Access Compliance Report

Public Rights-of-Way

(Pedestrian Signals)

Intersection ID: N/A	Main Street:	Cross Street: N/A	Location: N/A
ADA ID: DCE3025C3DAA	Signal Type: One Push Button-APS	Overall Compliance: No	Severity Score: BTN 1: N/A BTN 2: N/A No BTN: N/A
Codes/Mitigation Info/Possible Solution		Field Measurements/Component Compliance

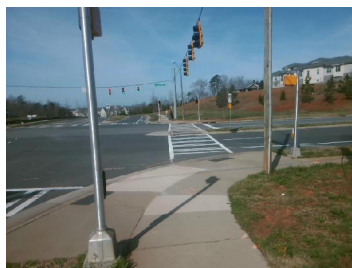
PROW/ADA: TMUTCD 4e.08, R404.2, R404.3, R406.2, R209.1, MUTCD 4e.10

Possible Solutions: Replace Signal Push Button With APS Button on New Post. Remove & Relocate Sign.
